New Tredegar

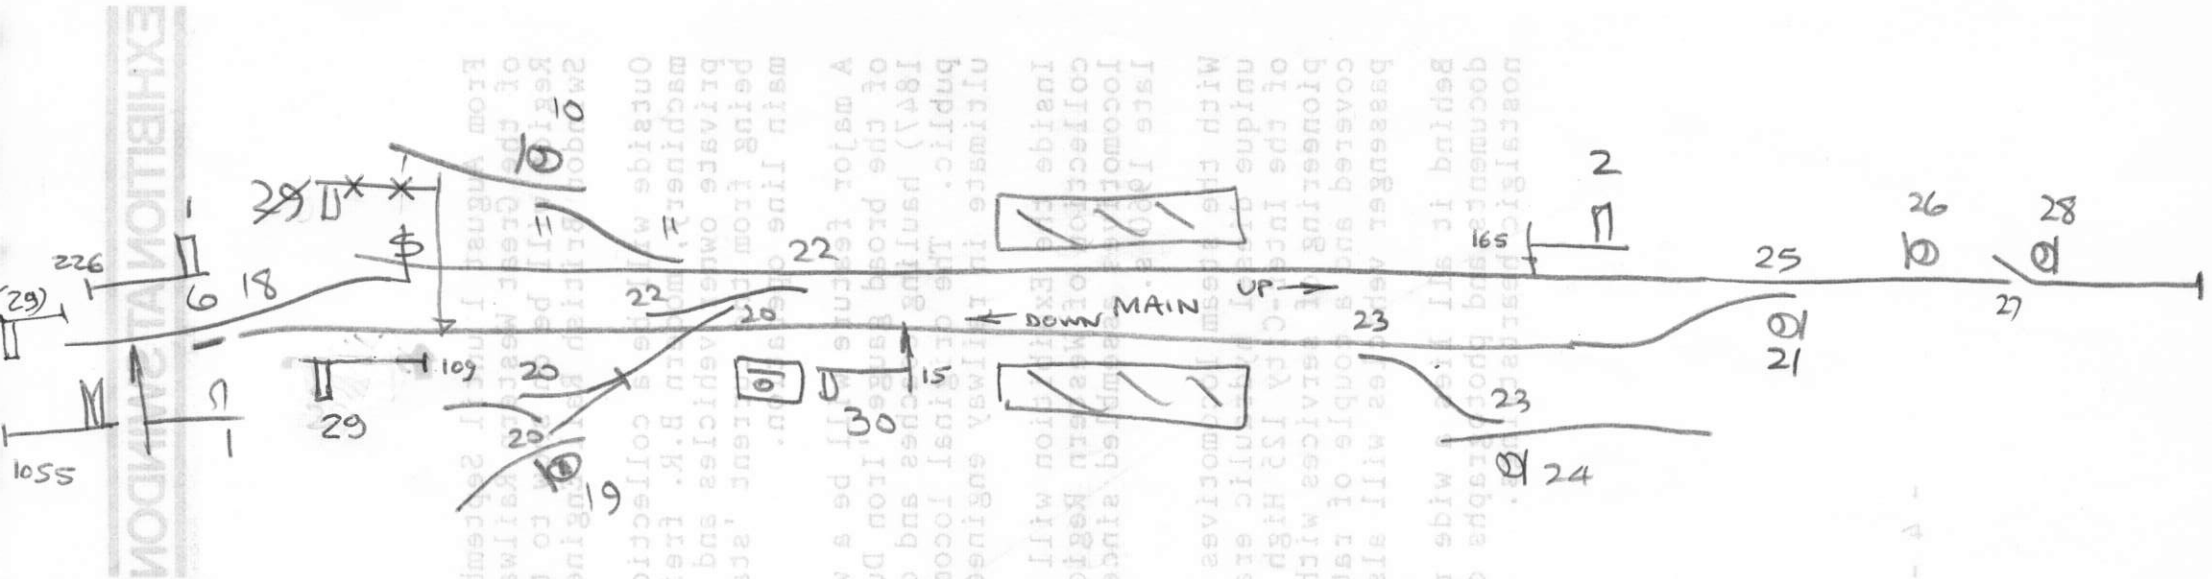
- ① Derived from locking chart and notice for Singling line. No 29 signal NB shown on notice. ~~it~~ section it was added afterwards. (Shown rubbed out on 2319/2 on up side of single line)
- ② Locking table to be checked by MRLI.

* ~~bob~~ is "New" on page 2!

* Notice No 127 DML starting has been fixed on Down side at 109 yds. not as shown in Notice No 121.

Distances from S2319/12 RE-TRAZED 23.9.49. (No 1 renewed on up side 2/10/49.)
